EMC2104 Silicon Errata and Data Sheet Clarification

TABLE 1: CHIP REVISION INFORMATION

FIGURE 1: PWM DRIVE SIGNAL INVERSION

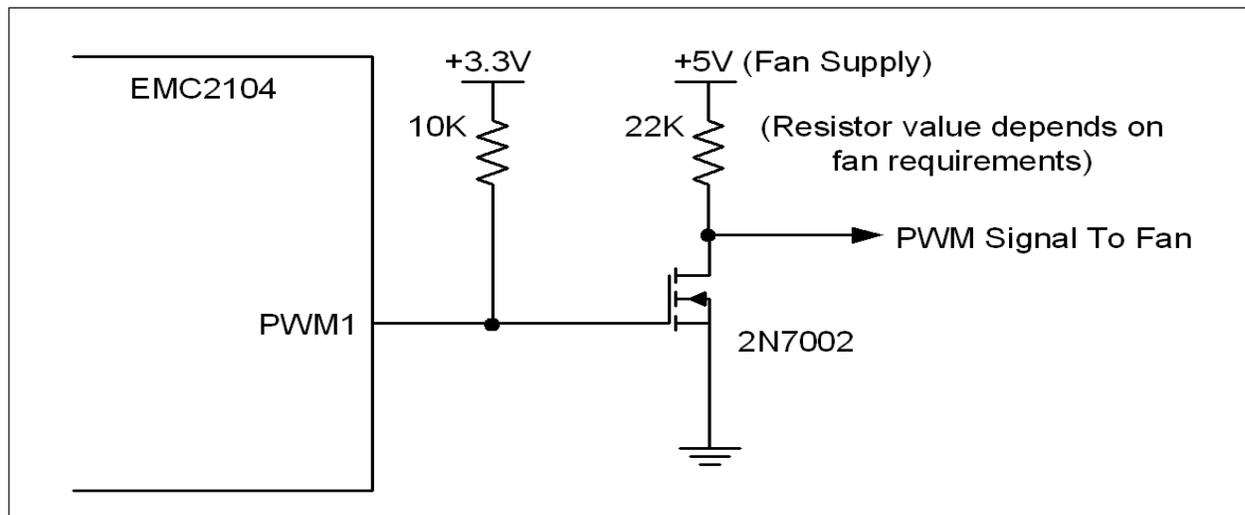
Errata 1: PWM1 Polarity Inverted

The PWM1 output is inverted so it is logic high when in the fan OFF condition.

This polarity inversion is opposite of the requirements for directly driving most 4-wire fans.

A signal inversion must be added. A typical circuit is shown in [Figure 1](#).
